South Texas Project Electric Generating Station P.O. Box 289 Wadsworth, Texas 77483

December 21, 2010  
U7-C-STP-NRC-100274

South Texas Project  
Units 3 and 4  
Docket Nos. 52-012 and 52-013  
Supplemental Response to Request for Additional Information

RAI 03.07.01-27, Supplement 1

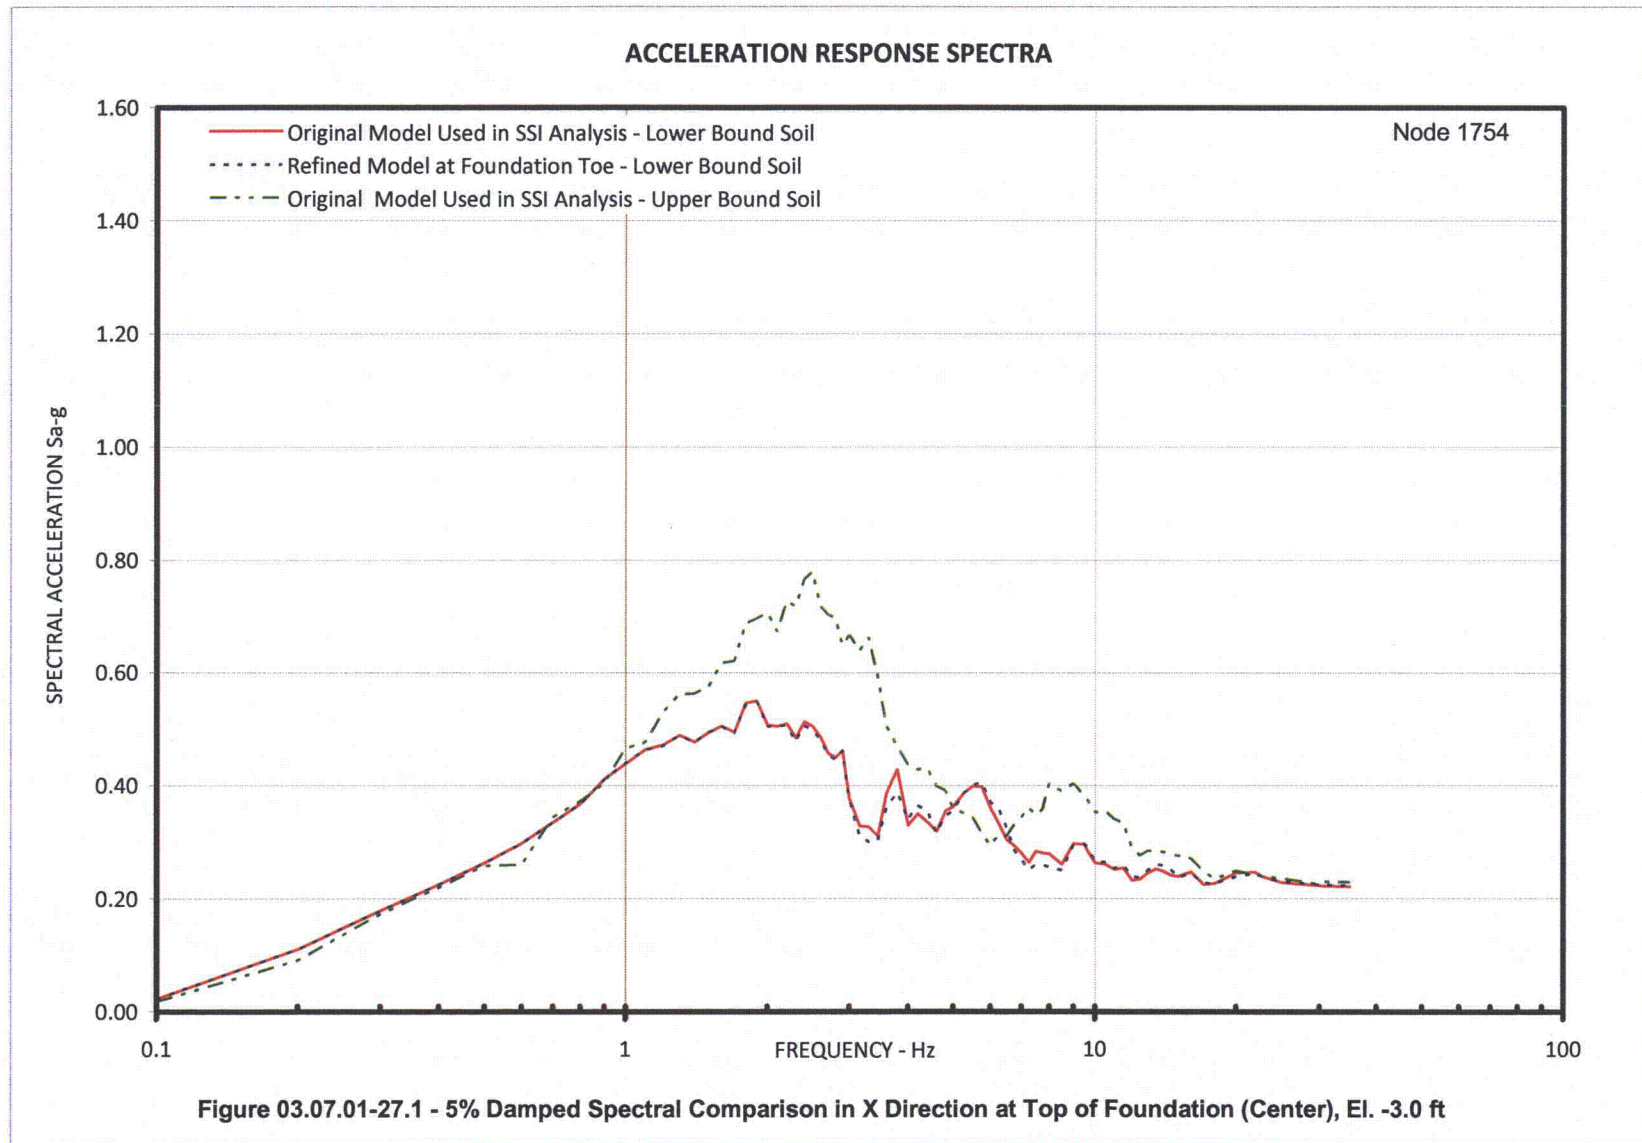
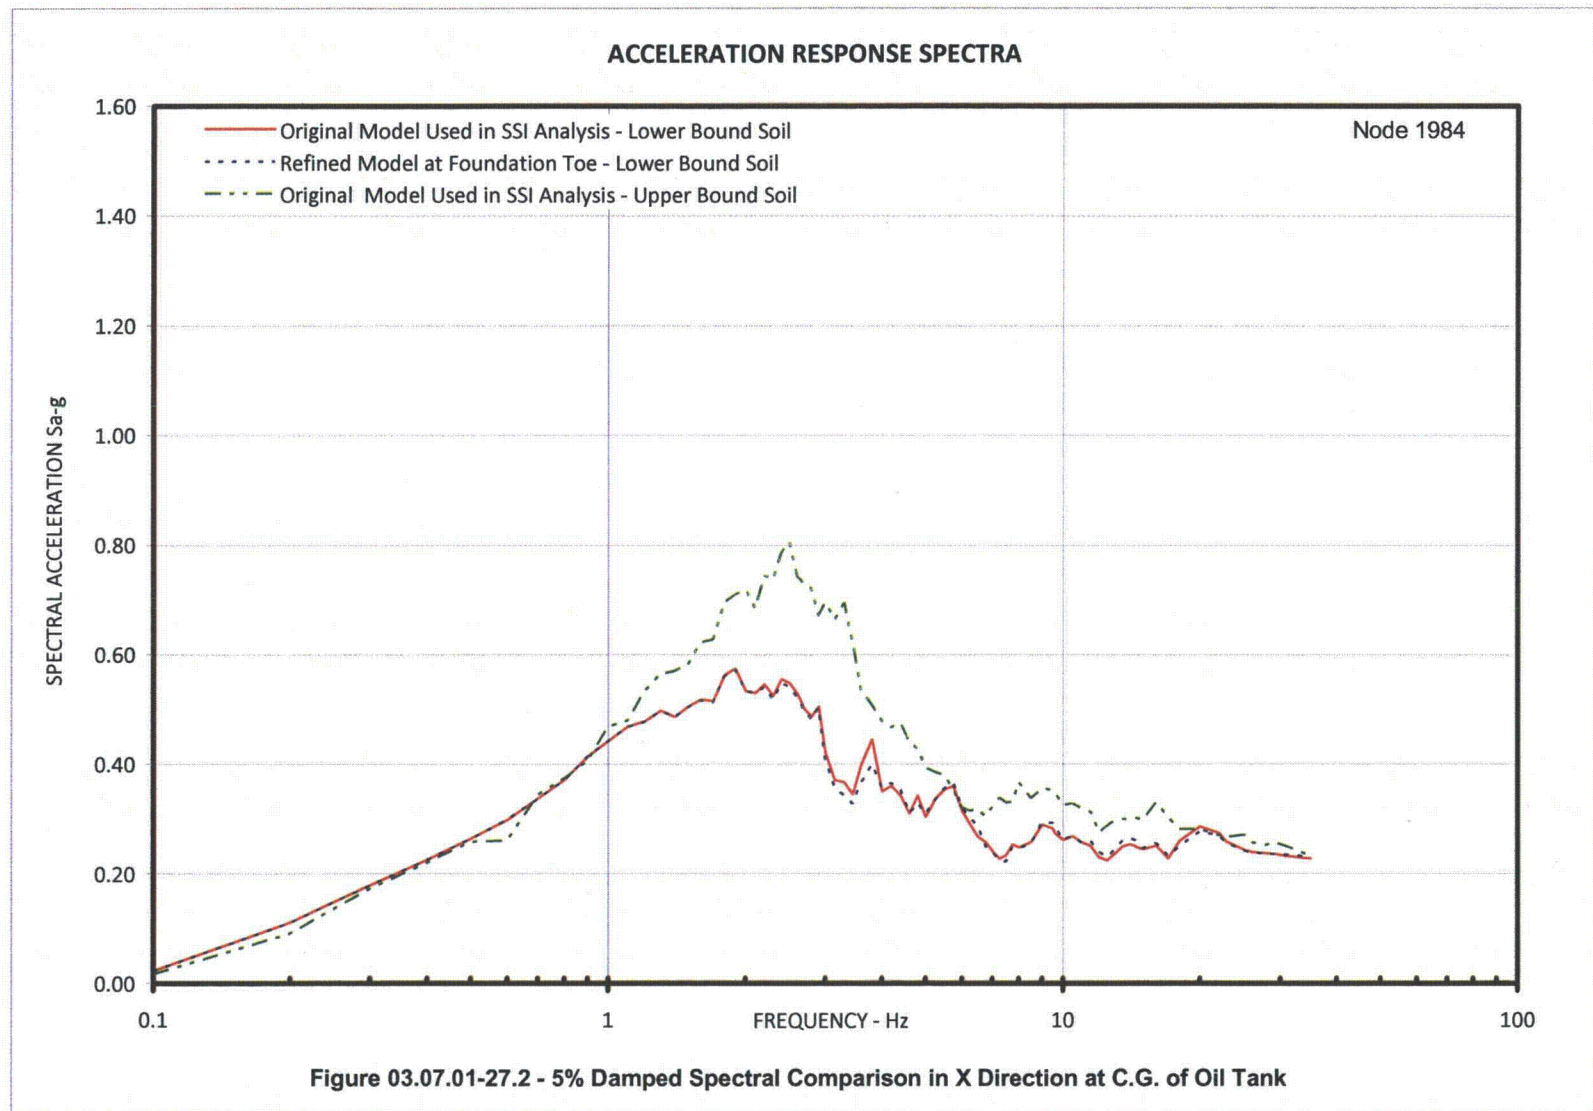
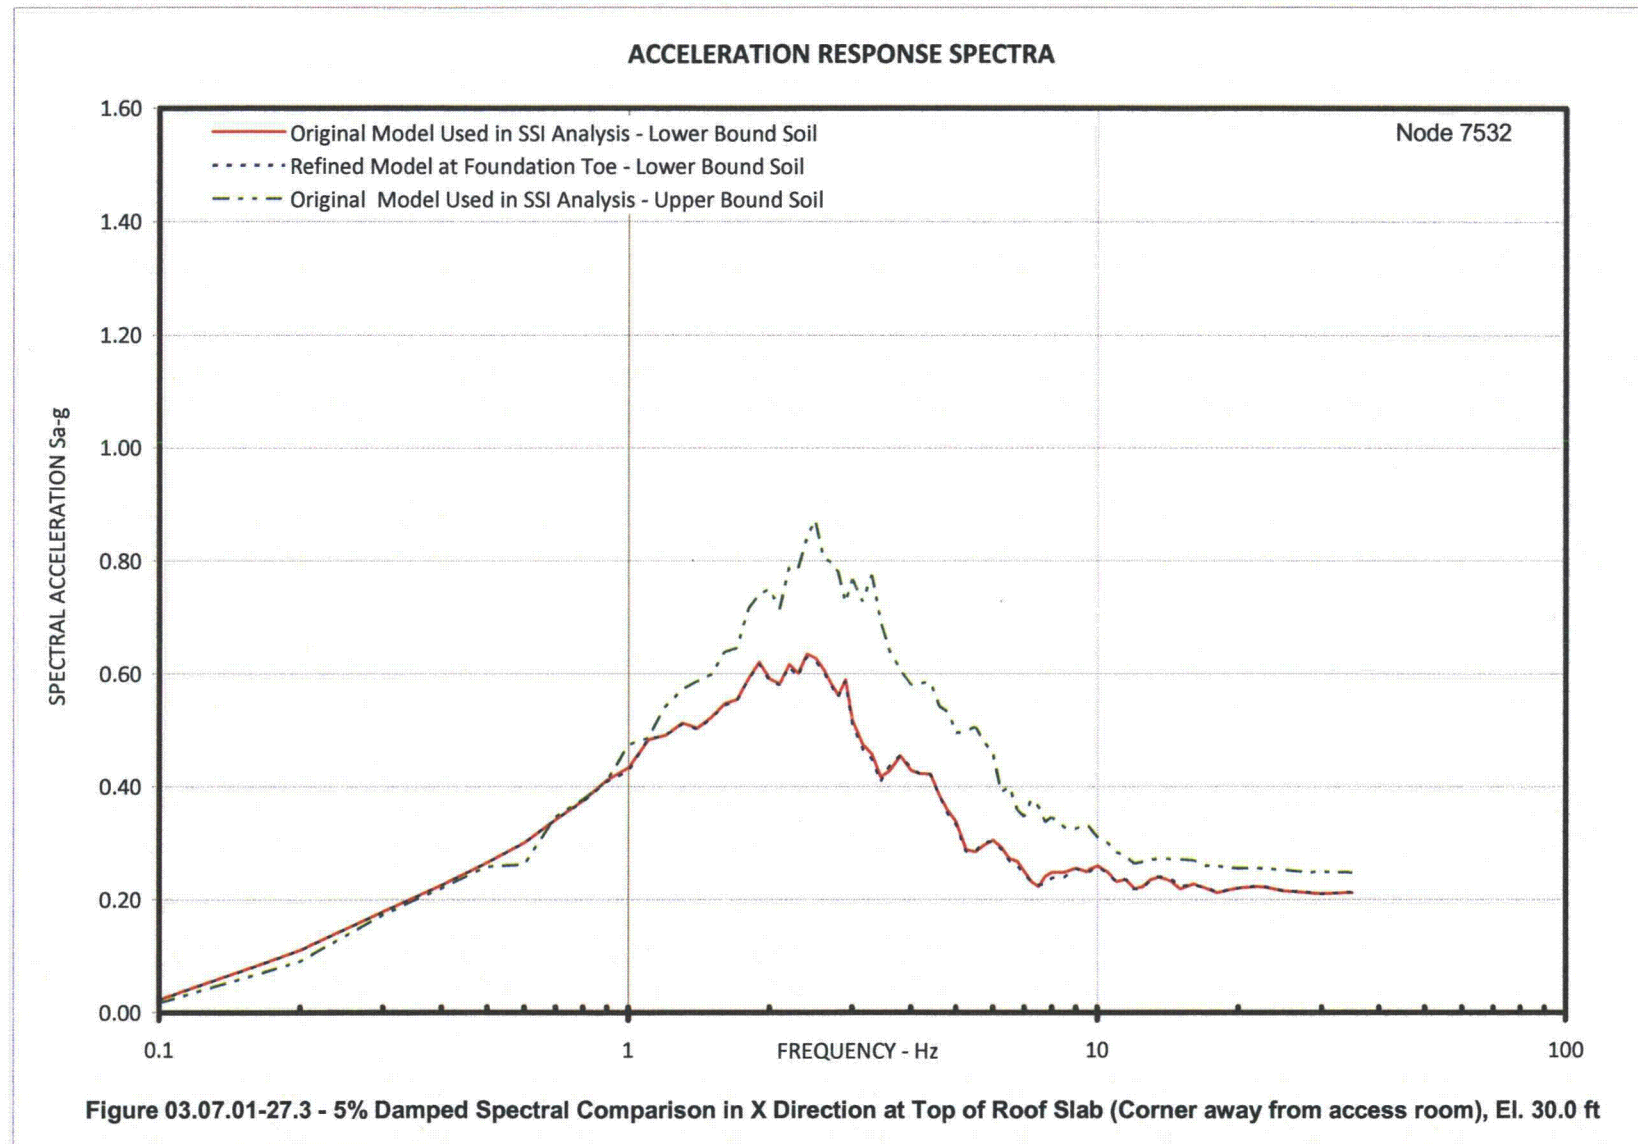
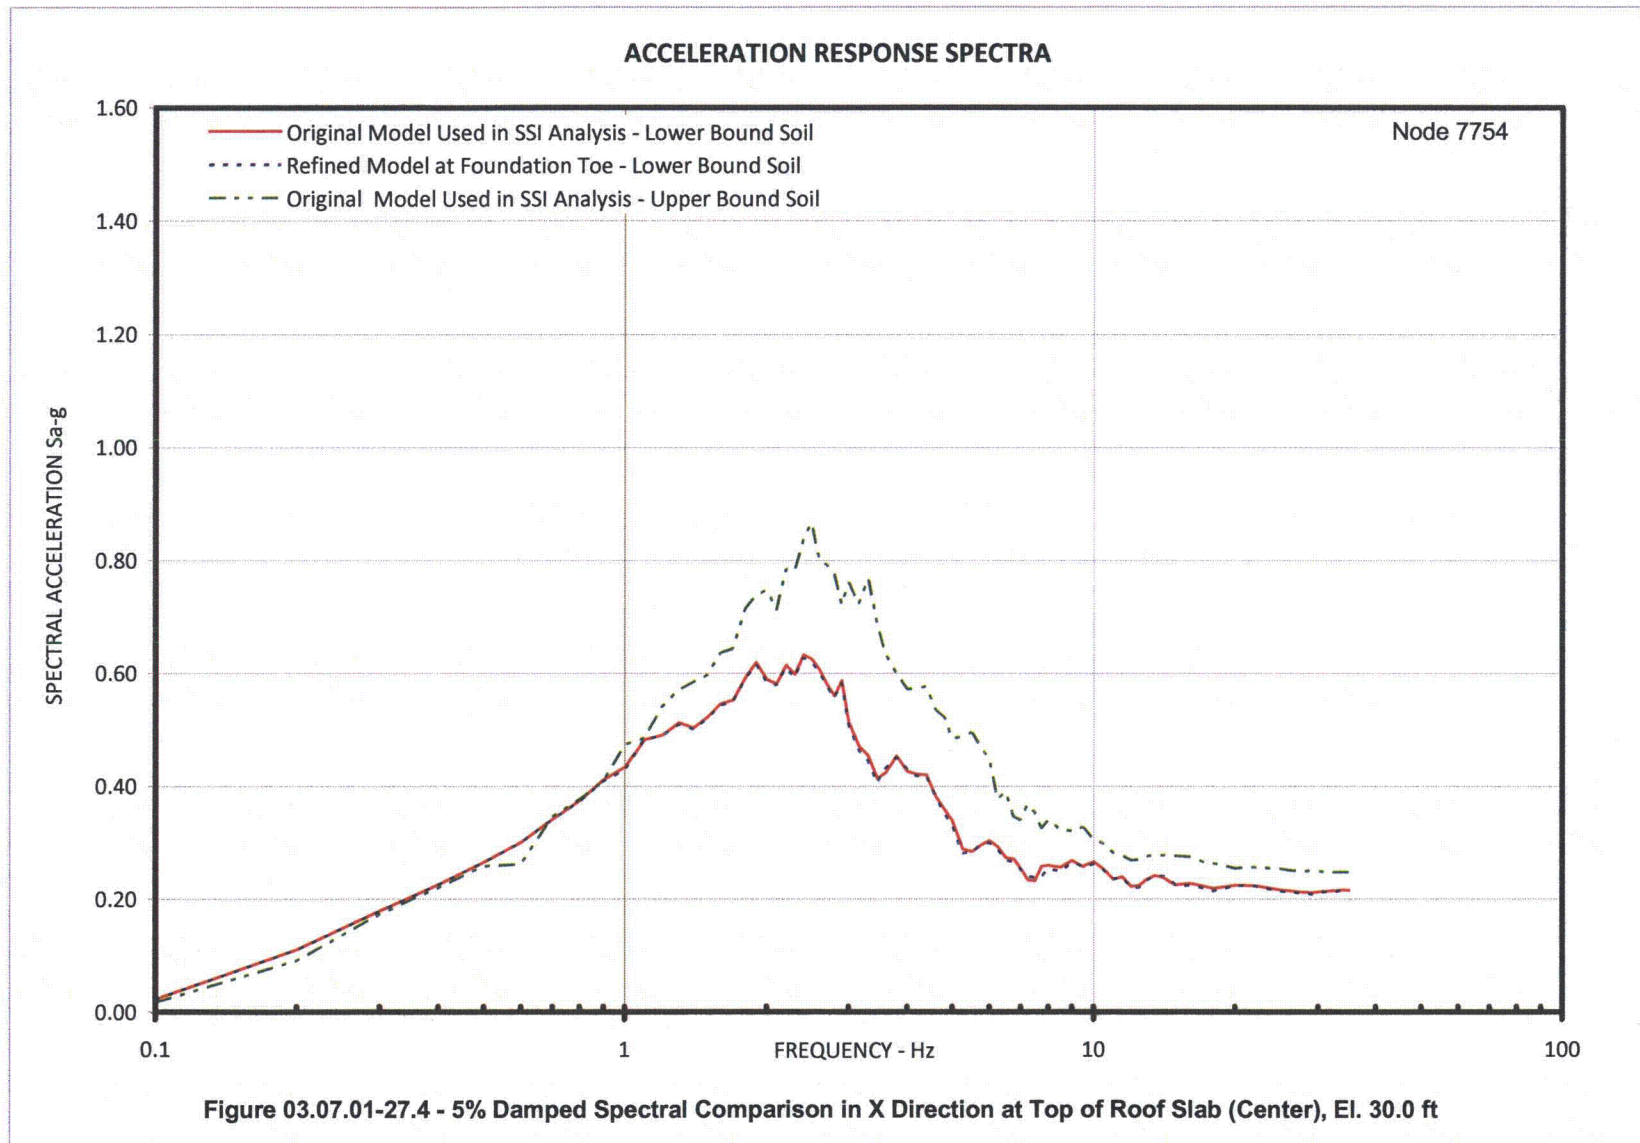
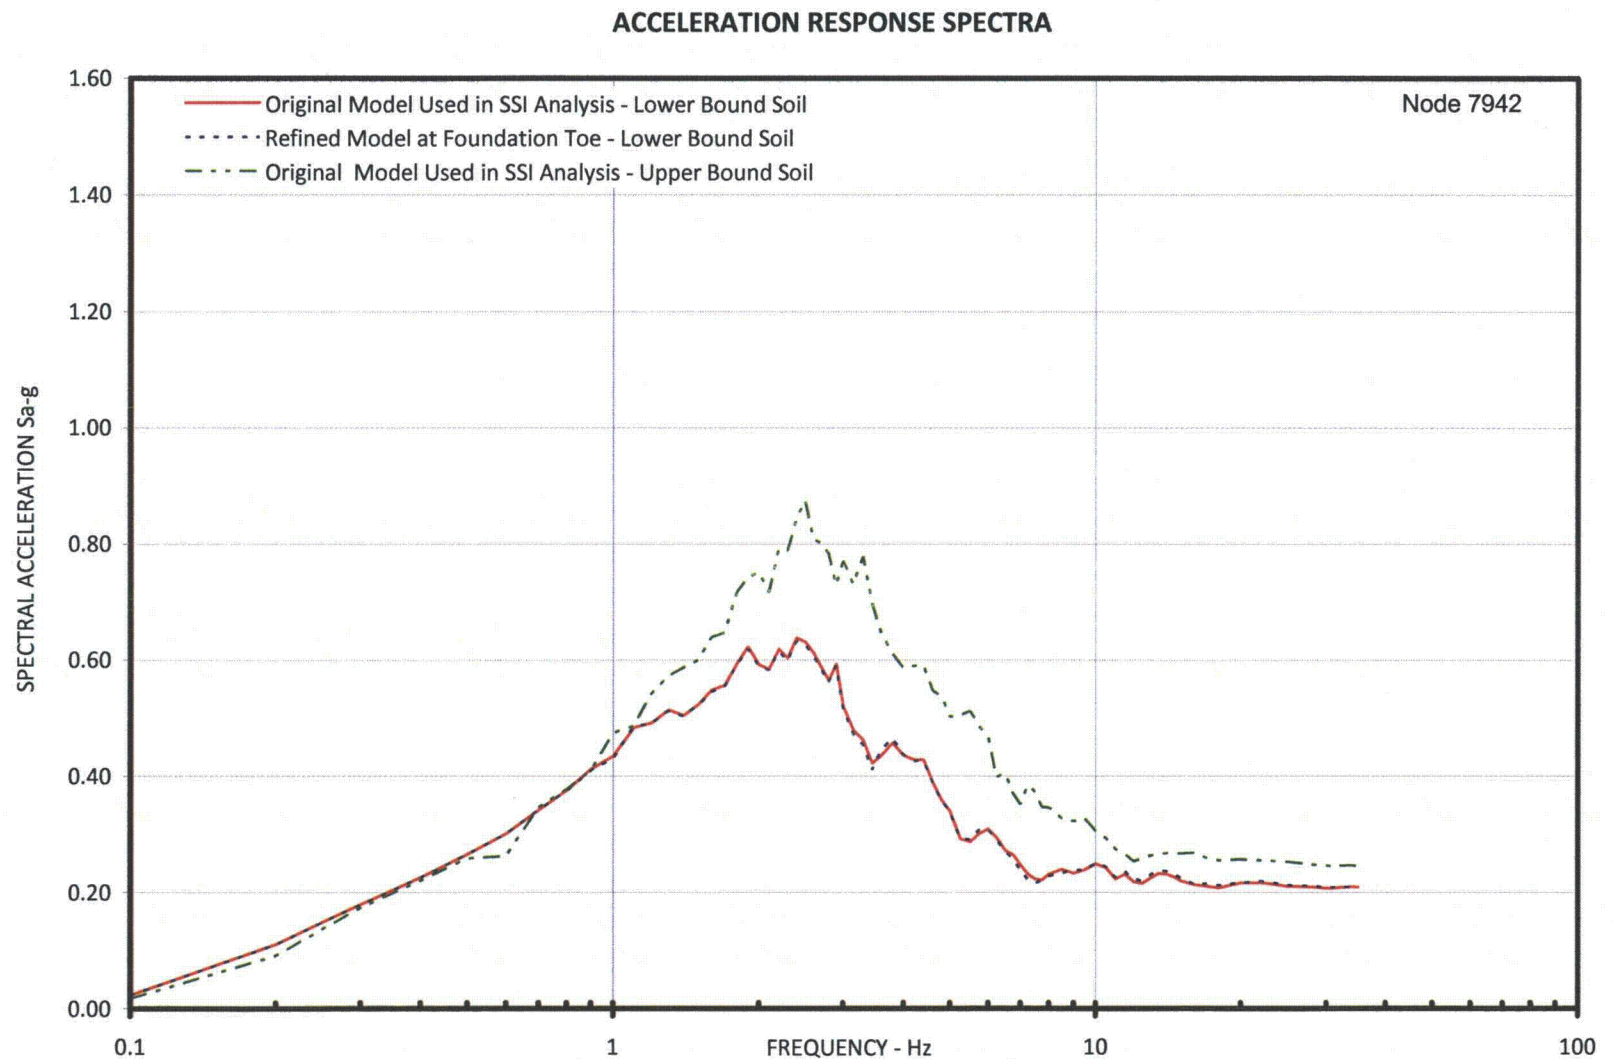
- (a) Describe in detail the method used for the SSI analysis of DGFOVS including the procedures for treatment of strain dependent backfill material properties in the model, input motion used and how it is specified in the analysis, variation of soil properties, and the computer programs used for SSI analysis.

To evaluate the effect of 20 Hz passing frequency for LB in-situ case, the foundation toe was divided into two elements, thus increasing the passing frequency to 40 Hz. This refined model with LB in-situ soil properties was analyzed and 5% damped spectra from this model were compared with the spectra from the original model with passing frequency of 20 Hz. The spectra comparison plots are shown in Figures 03.07.01-27.1 through 03.07.01-27.24. The comparison shows that:

- In the X direction, there is insignificant difference between the response spectra from the two models
- In the Y direction, the response spectra from the two models matched well except at frequency of about 3.8 Hz where the refined model produced higher spectra. However, spectra from both the models are enveloped by the spectra for UB in-situ soil case
- In the vertical direction, the spectra from the two models matched well (insignificant difference)

Based on the above evaluation it is concluded that the horizontal direction passing frequencies are acceptable.
